To: T10 Committee (SCSI)

From: George Penokie (IBM/Tivoli)

Subject: SAS 1.1 - Transport layer retry and argument passing fixes

Figure 149 — ST_I (transport layer for SSP initiator ports) state machines

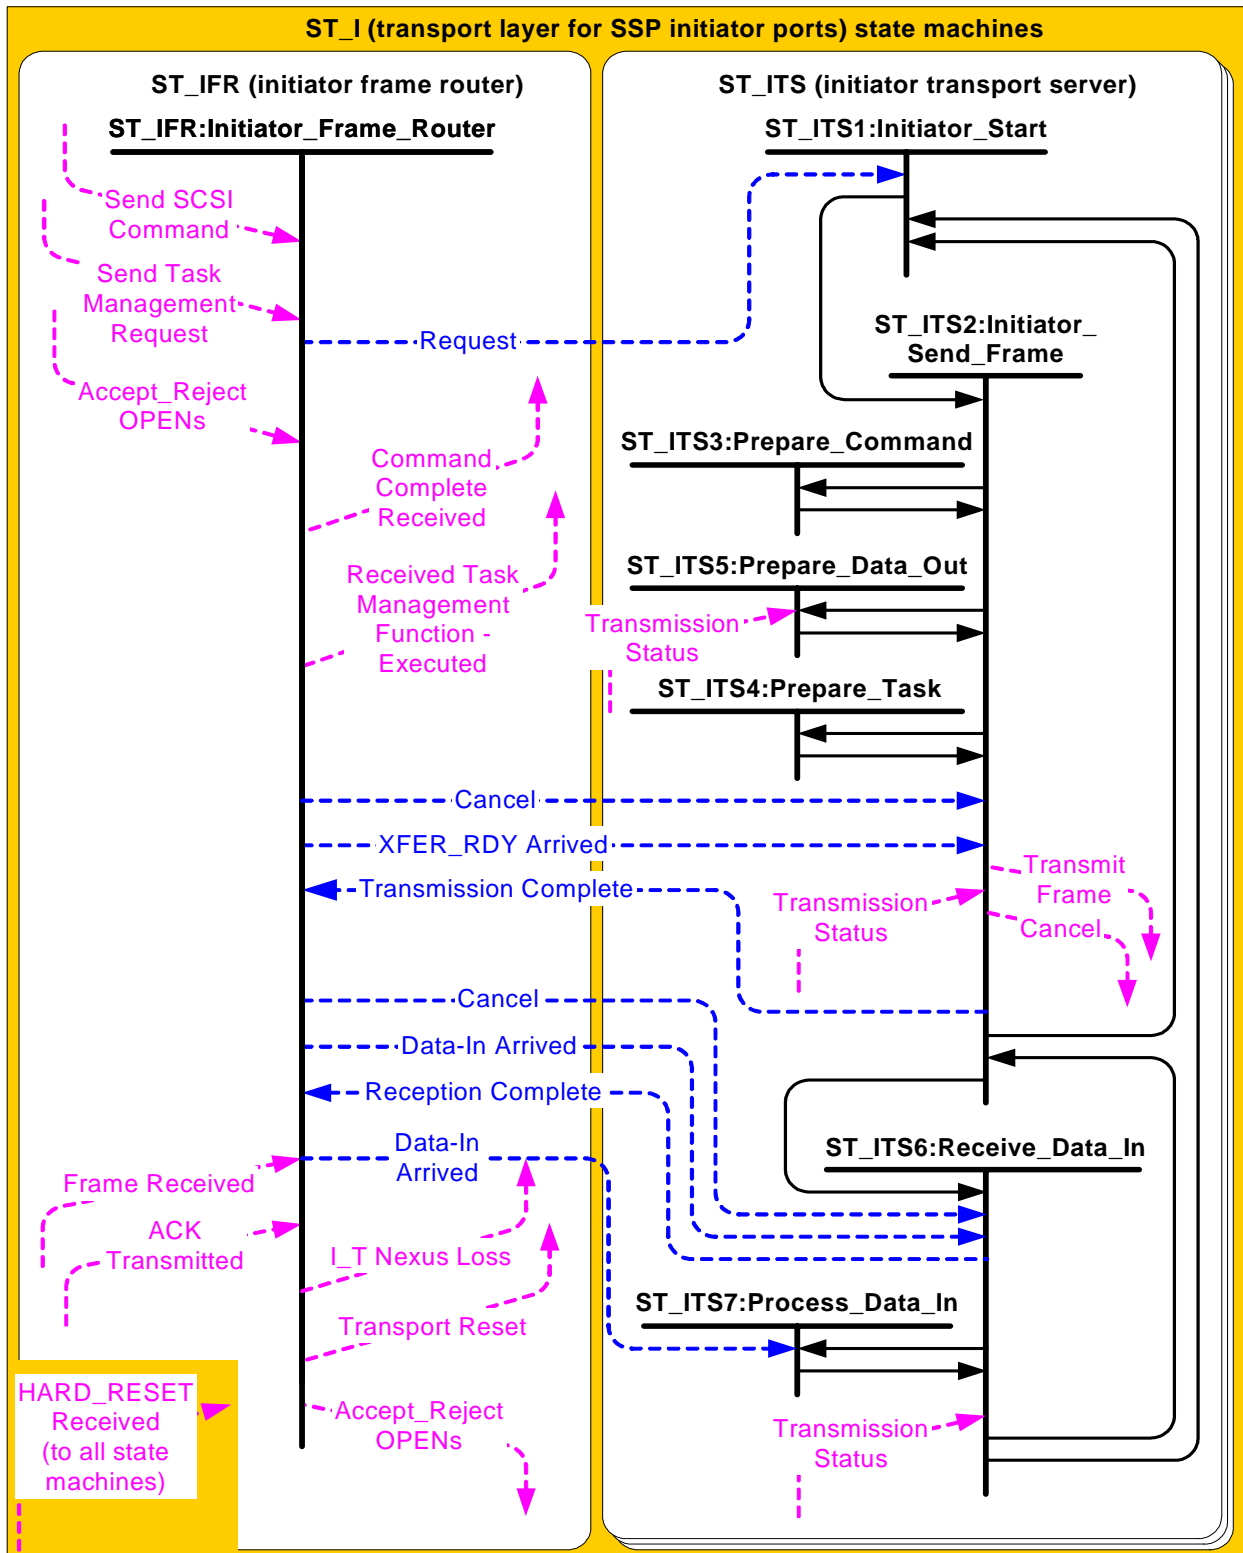
Editor's Note 13: Added Data-In Arrived message into ST_ITS7 and Transmission Status

[confirmation into ST_ITS5 to allow for non-interlocked DATA frame transfers.](#)

Figure 150 — ST_T (transport layer for SSP target ports) state machines

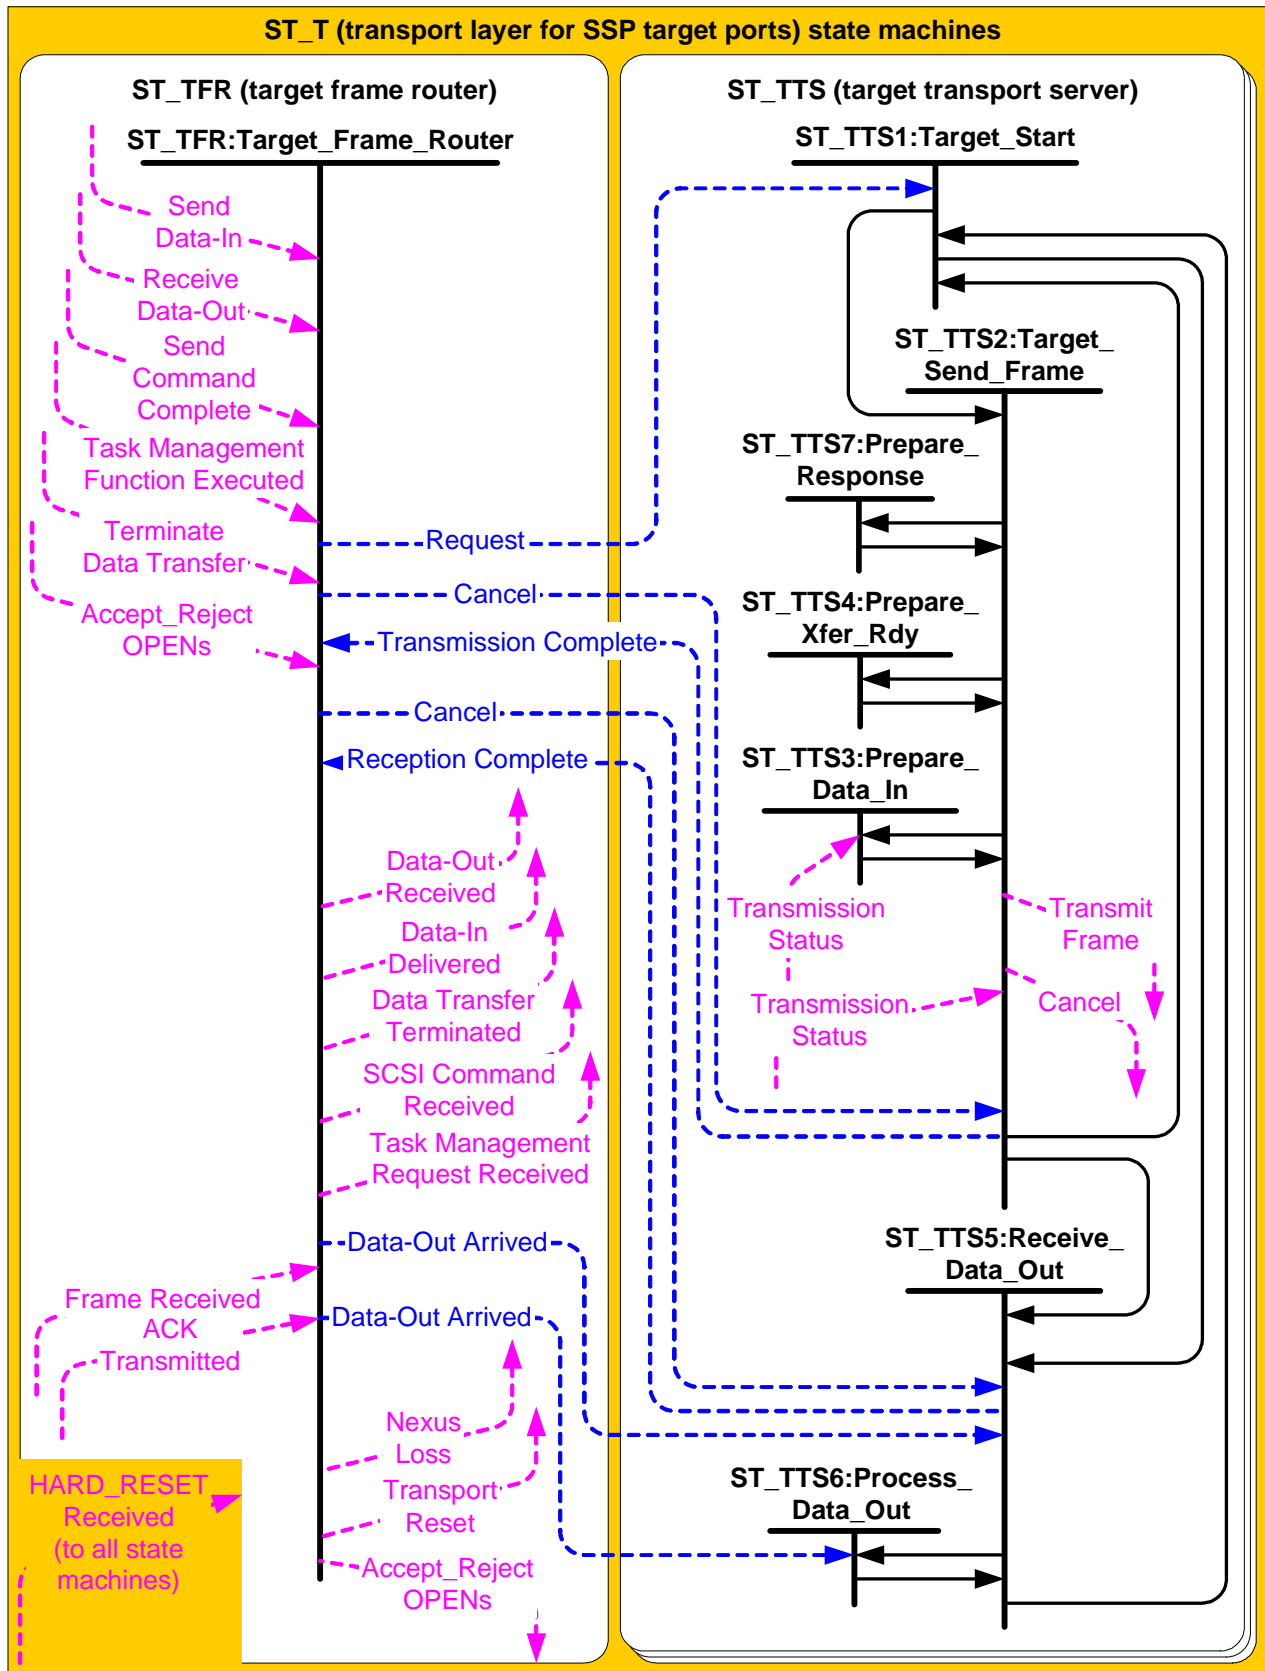
[Editor's Note 14: Added Data-Out Arrived message into ST_TTS6 and Transmission Status confirmation into ST_TTS3 to allow for non-interlocked DATA frame transfers. Also removed the ST_TTS5 to ST_TTS2 transition which was not defined in SAS 1.1. rev 9 and is not needed.](#)

Figure 151 — ST_I (transport layer for SSP initiator ports) state machines

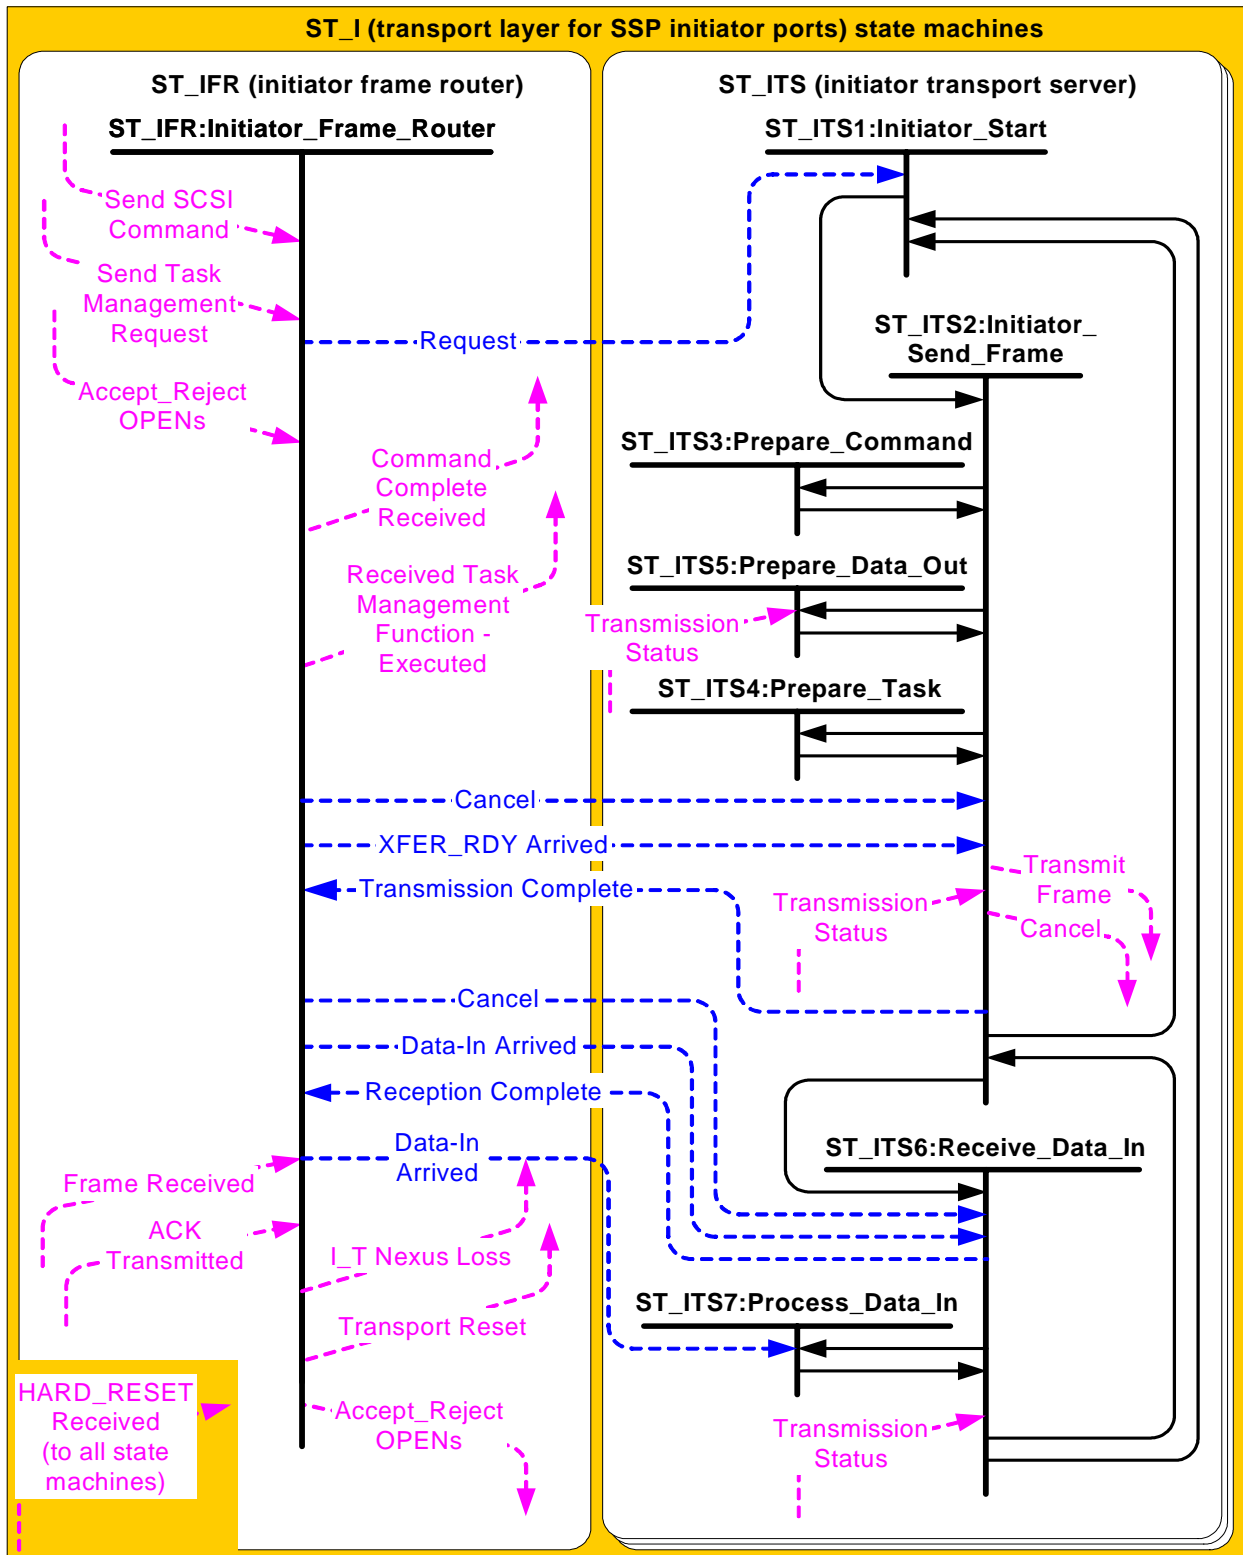
Editor's Note 15: Added Data-In Arrived message into ST_ITS7 and Transmission Status

Figure 152 — ST_T (transport layer for SSP target ports) state machines

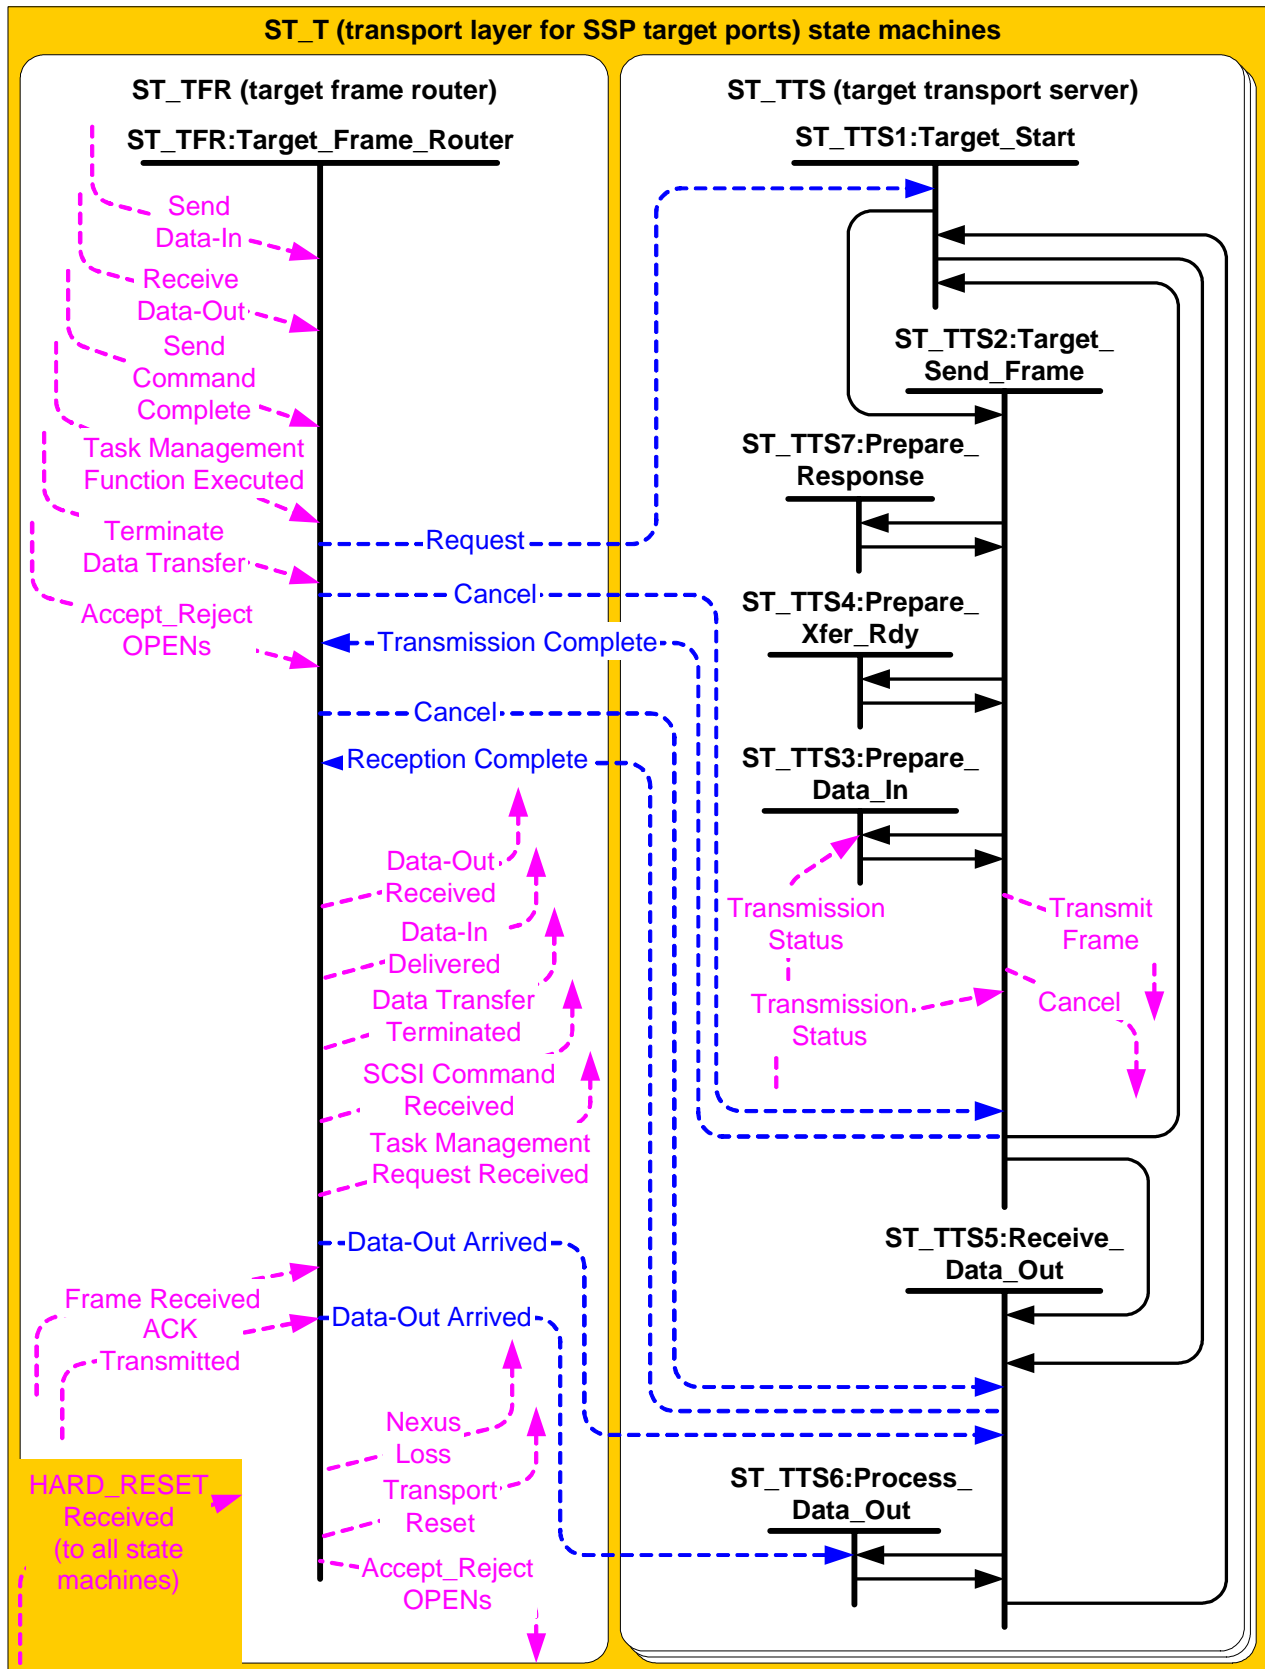
Editor's Note 16: Added Data-Out Arrived message into ST_TTS6 and Transmission Status confirmation into ST_TTS3 to allow for non-interlocked DATA frame transfers. Also removed the ST_TTS5 to ST_TTS2 transition which was not defined in SAS 1.1. rev 9 and is not needed.
